GULF STATES UTILITIES COMPANY

River Bend Station - Unit 1
Docket No. 50-458

Proposed revisions to FSAR Sections 1.8, 8.3.1 and 14.2 are enclosed for your information. These revisions have been previously discussed with your staff and will be appropriately included in a future FSAR amendment.

The purpose of these revisions is to establish a qualified load for each of the diesel generators, to provide revised positions on Regulatory Guides 1.9 and 1.108 and to address HPCS independence. Gulf States Utilities will be in contact with the Nuclear Regulatory Commission Project Manager regarding submittal of additional information to support these revisions.

FIGURE 8.3-14A

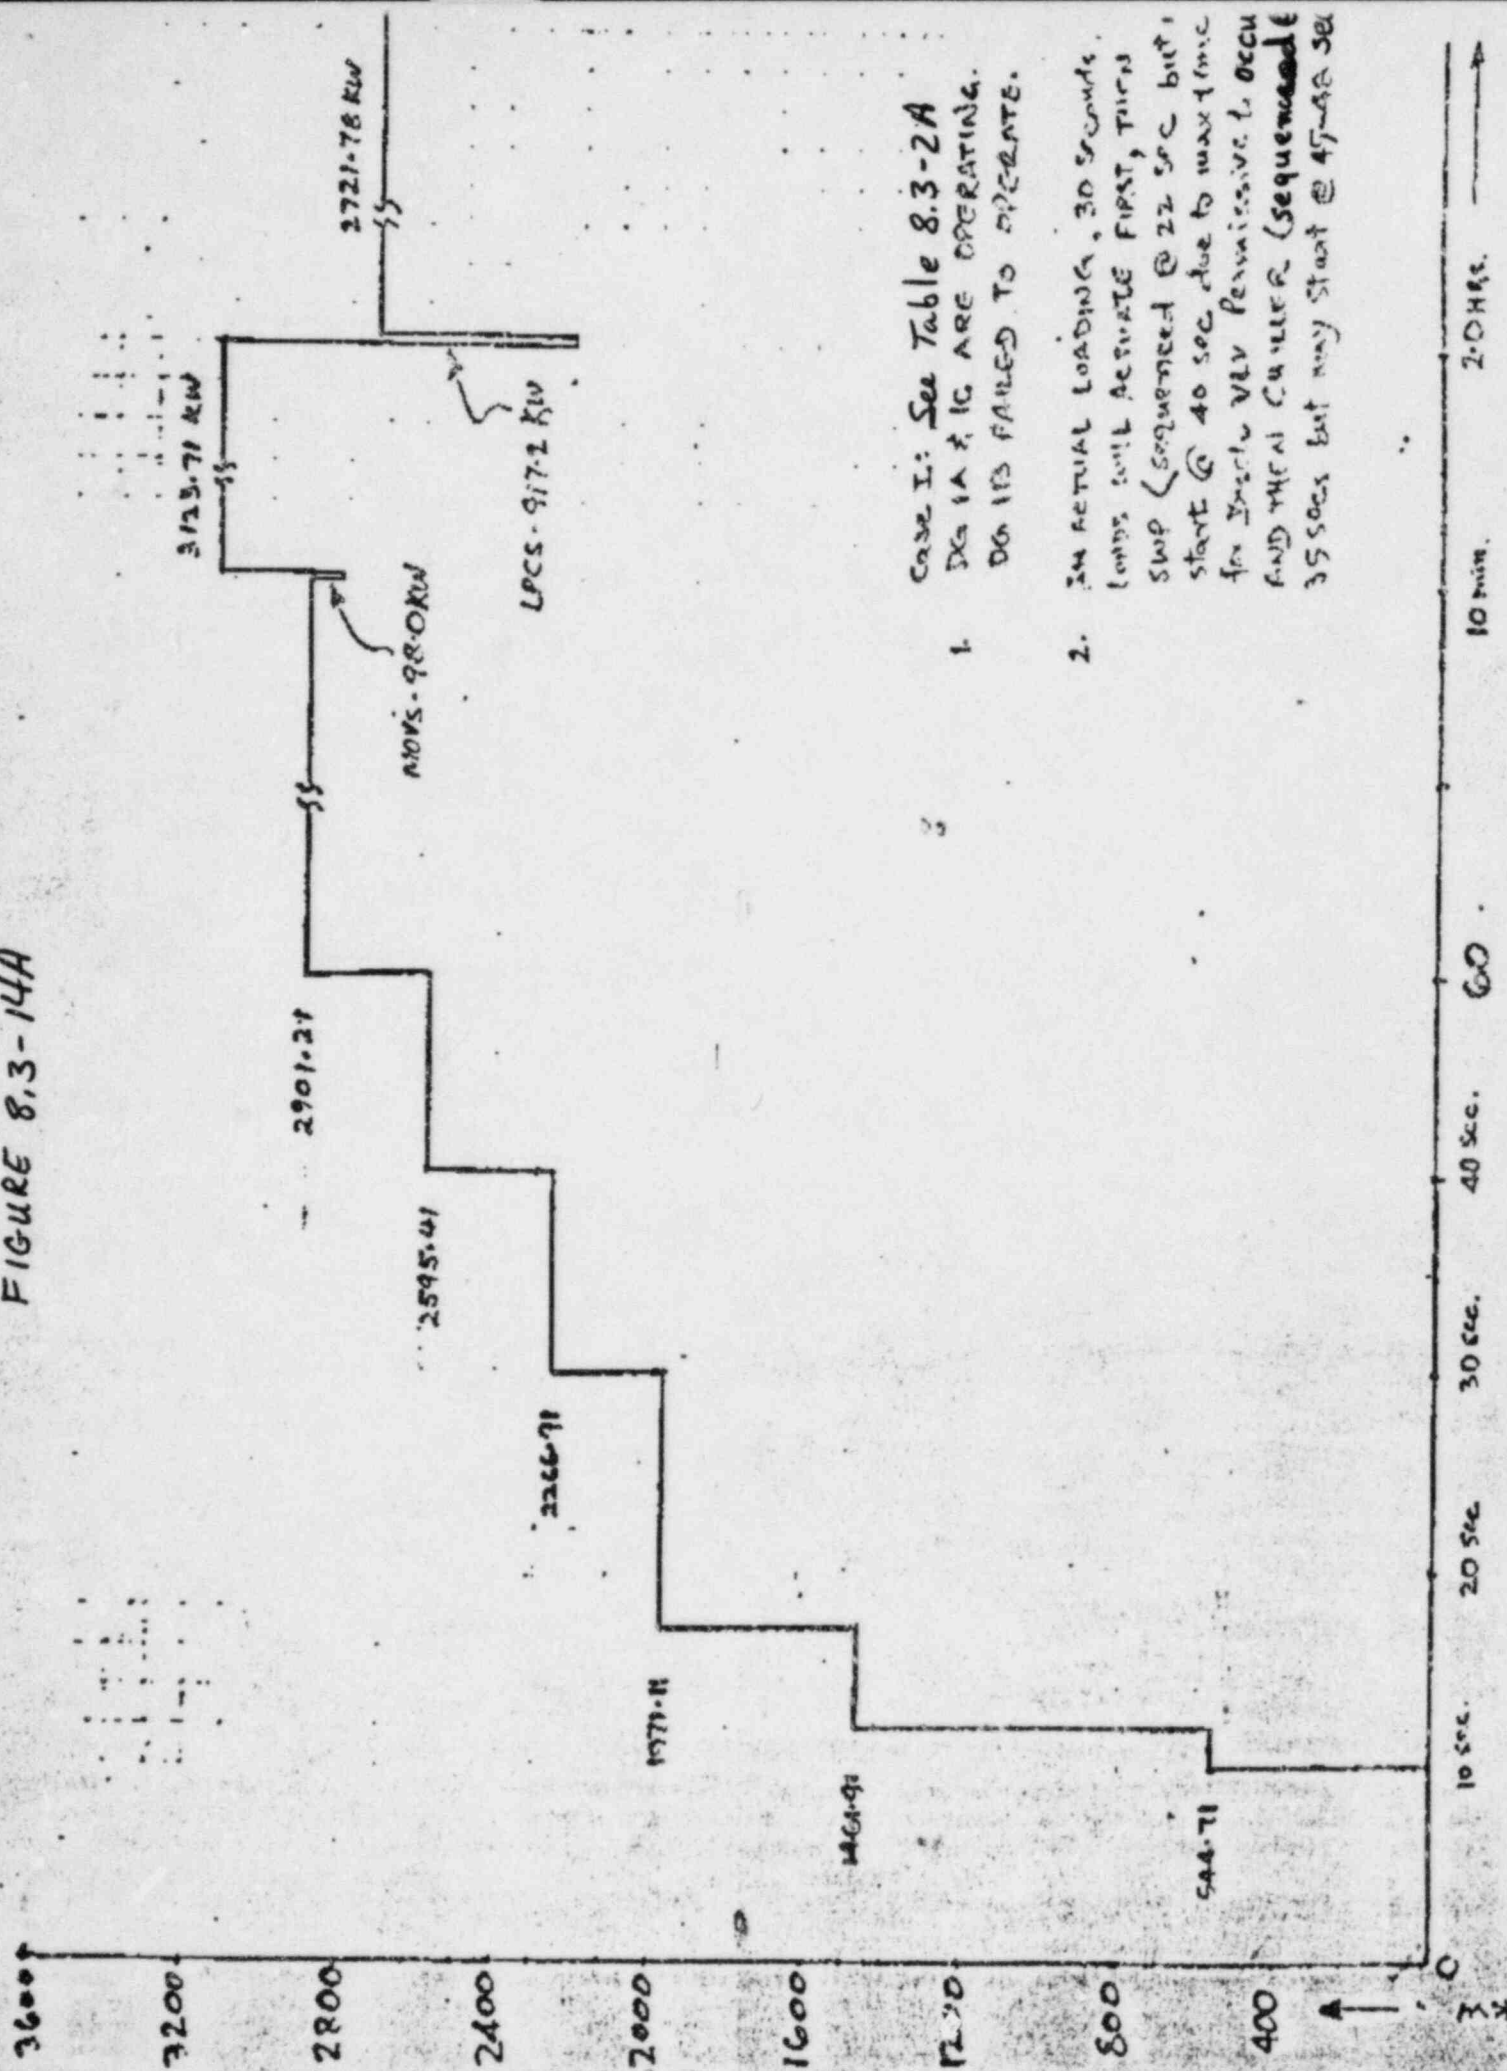
Case I: See Table 8.3-2A

1. DA 1A & 1C ARE OPERATING. DA 1B IS FAULTED TO OPERATE.

2. IN ACTUAL LOADING, 30 SECONDS LAMPS WILL ACTIVATE FIRST, THEN SWP (SEQUENCED @ 22 SEC BUT START @ 40 SEC DUE TO MAX TIME FOR BUCKLE VALV PERMISSIVE TO OCCUR AND THEN CHILLER (SEQUENCED @ 35 SECS BUT MAY START @ 45-48 SEC)

FIGURE 8.3-14B

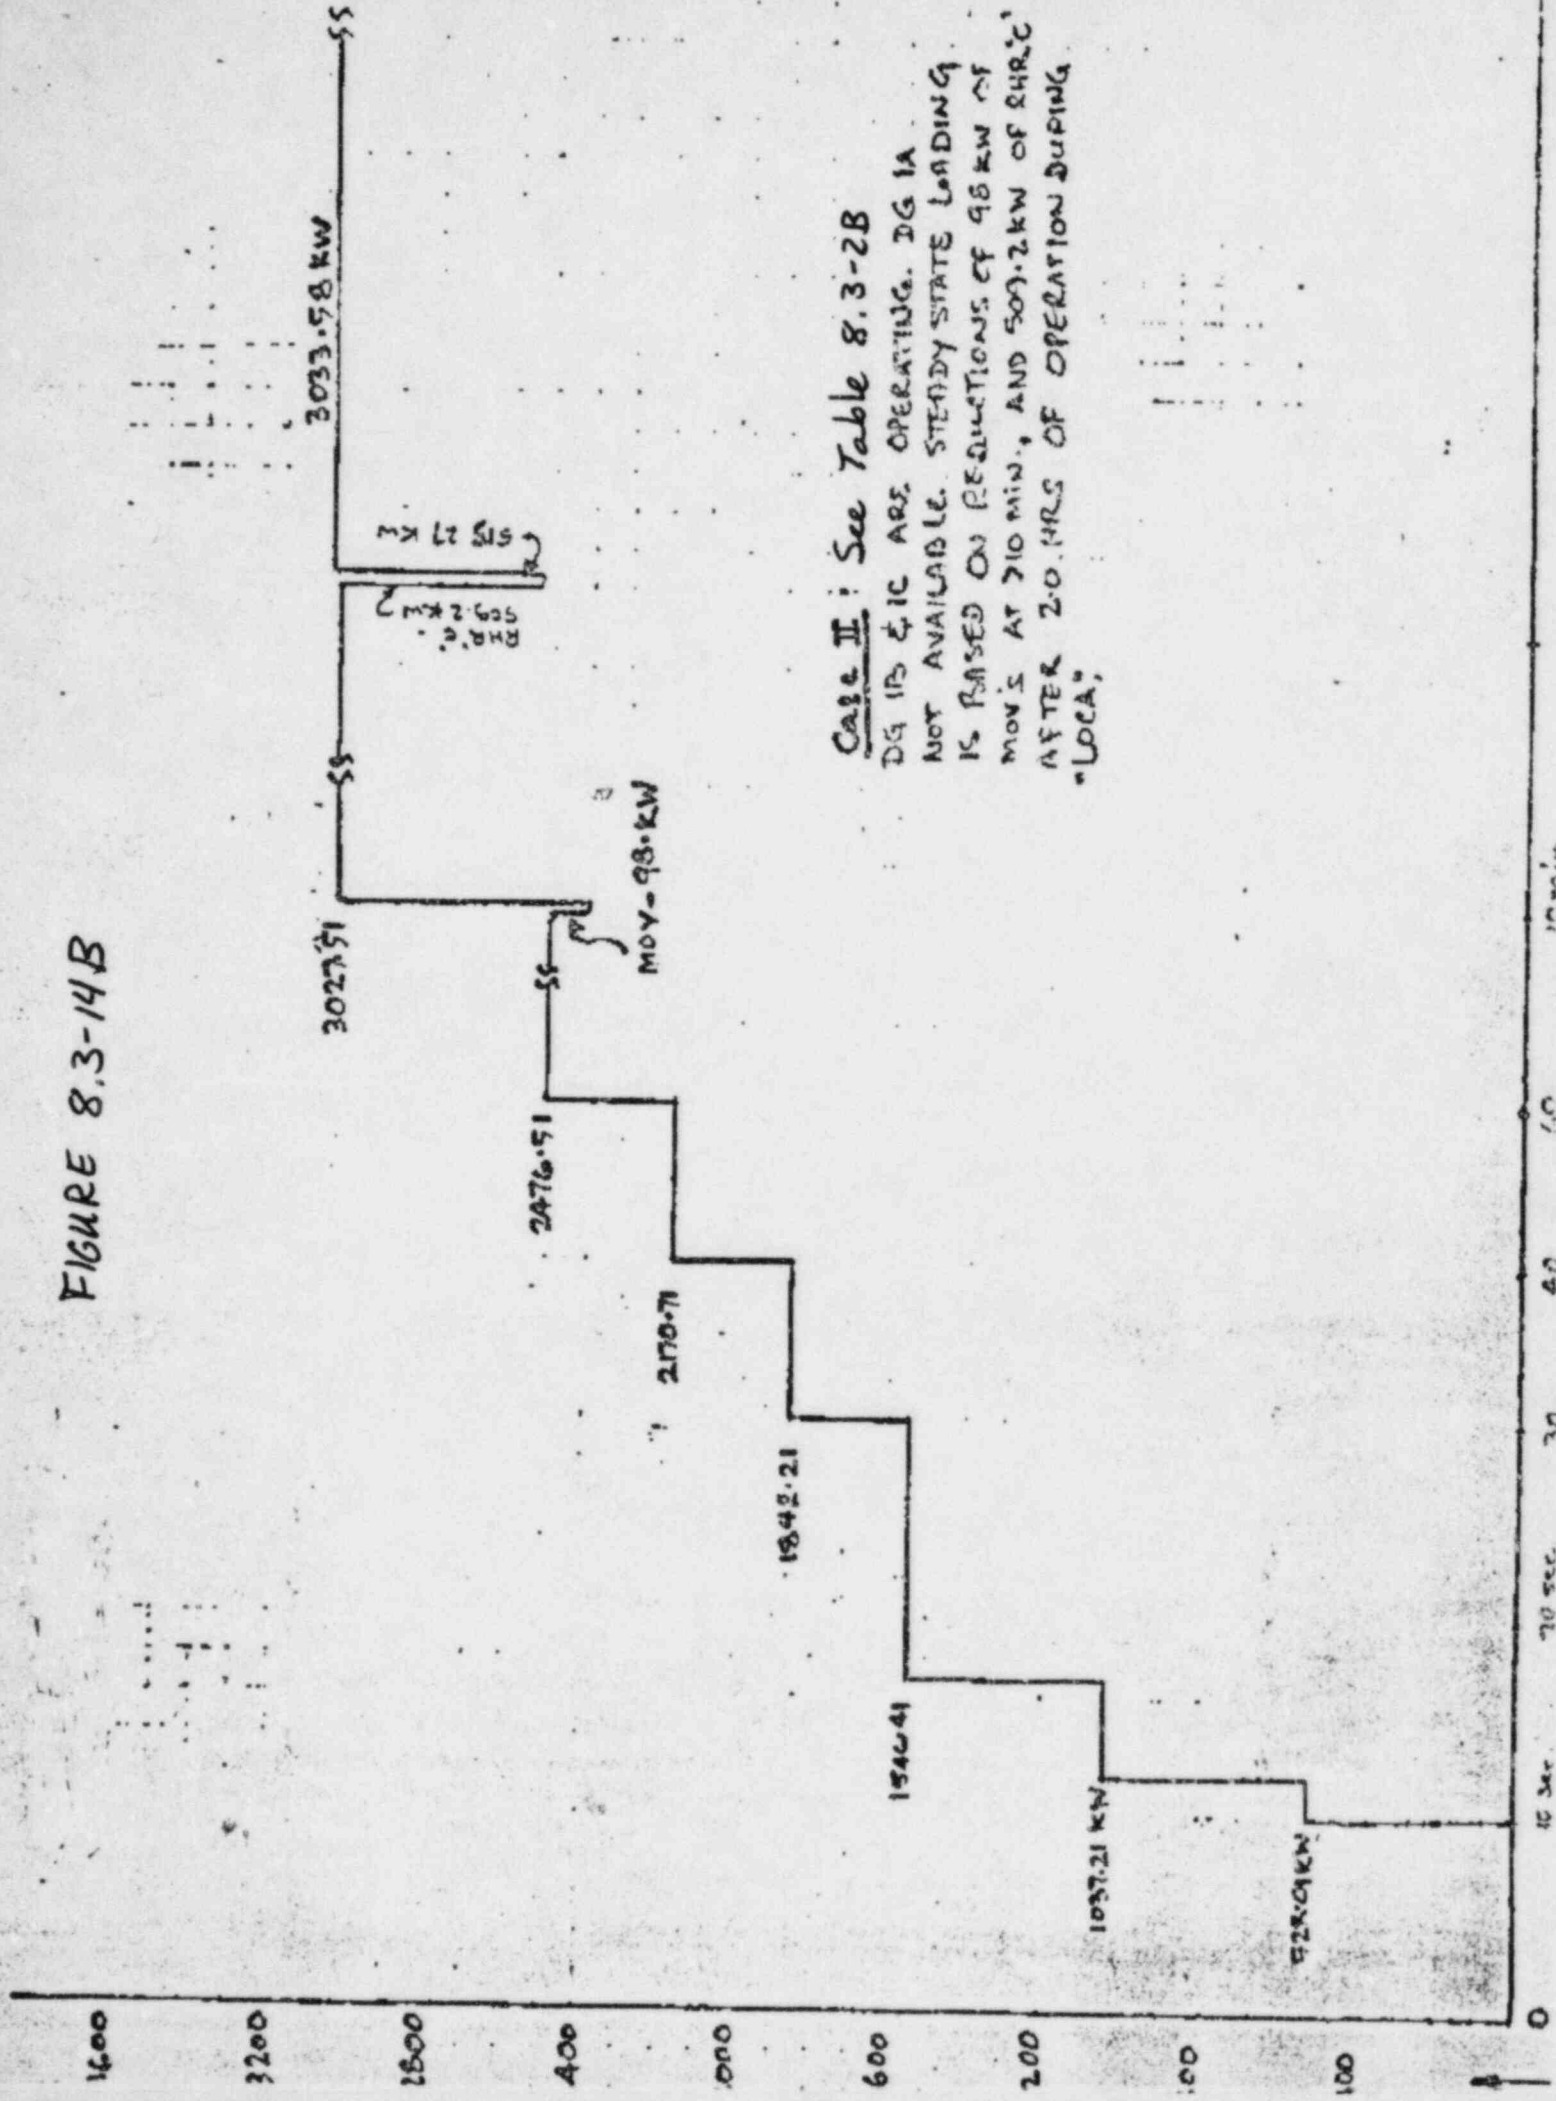
Case II: See Table 8.3-2B

DG 1B & 1C ARE OPERATING. DG 1A NOT AVAILABLE. STEADY STATE LOADING IS BASED ON REQUIREMENTS OF 98 KW OF MOV'S AT 710 MIN., AND 509.2 KW OF RHR'S AFTER 2.0 HRS OF OPERATION DURING "LOCA".

FIGURE 8.3-15B

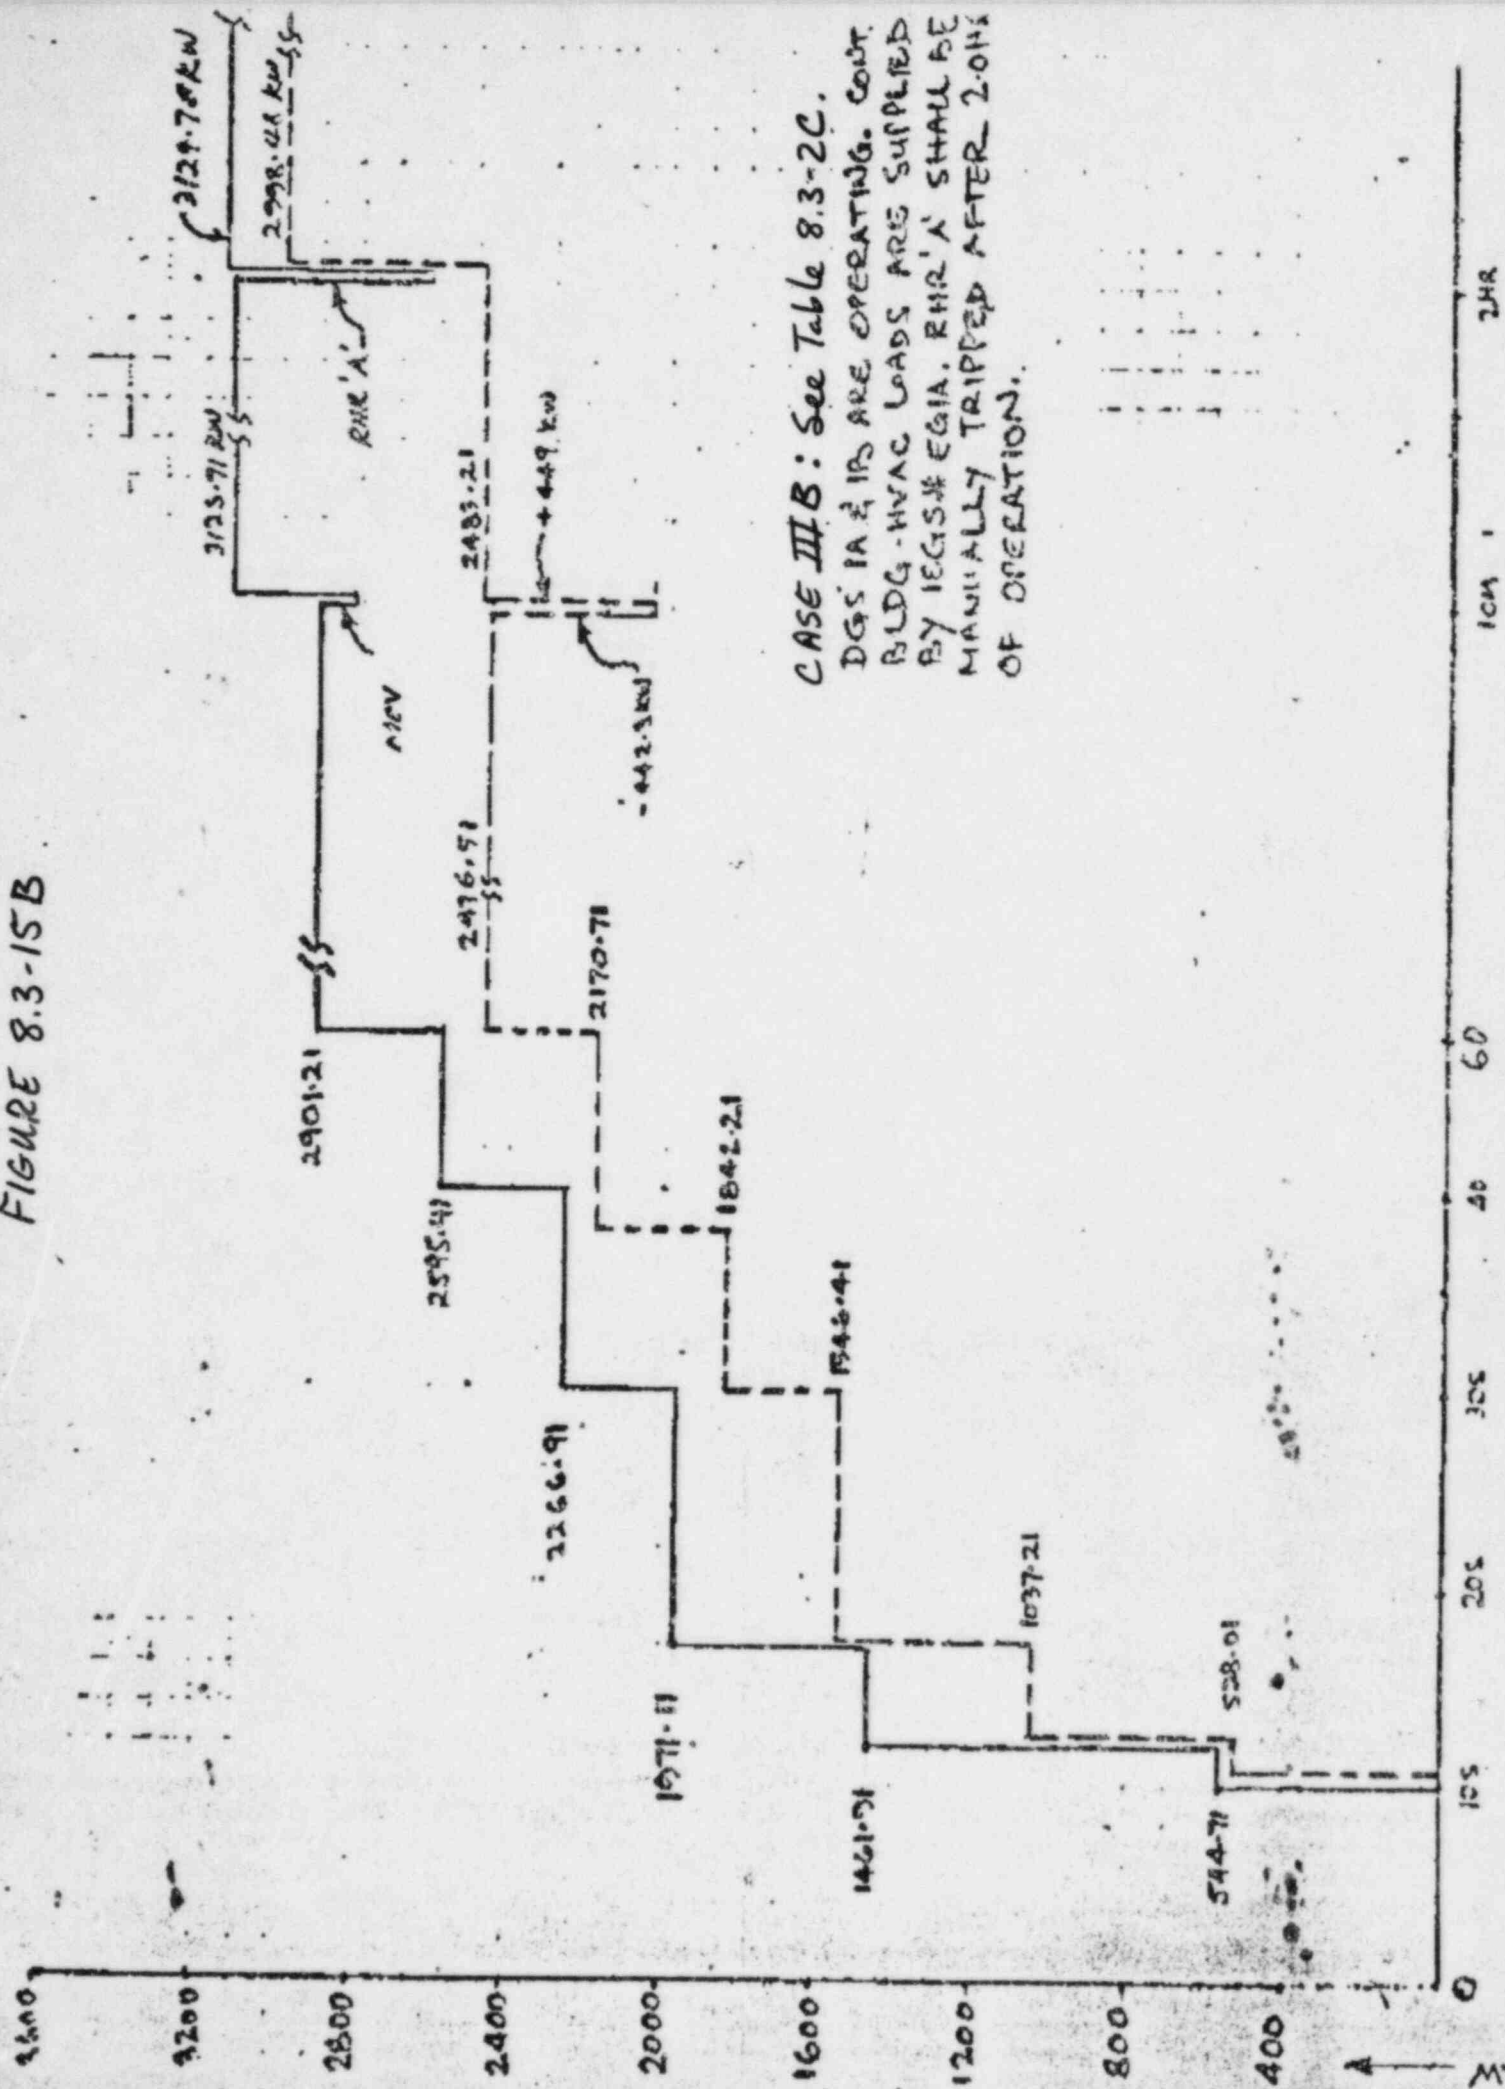
CASE III B: See Table 8.3-2C.
 DGS 1A & 1B ARE OPERATING. CONT.
 BLDG. HVAC LOADS ARE SUPPLIED
 BY 1EGS# EGIA. RHR 'A' SHALL BE
 MANUALLY TRIPPED AFTER 2.0Hrs
 OF OPERATION.
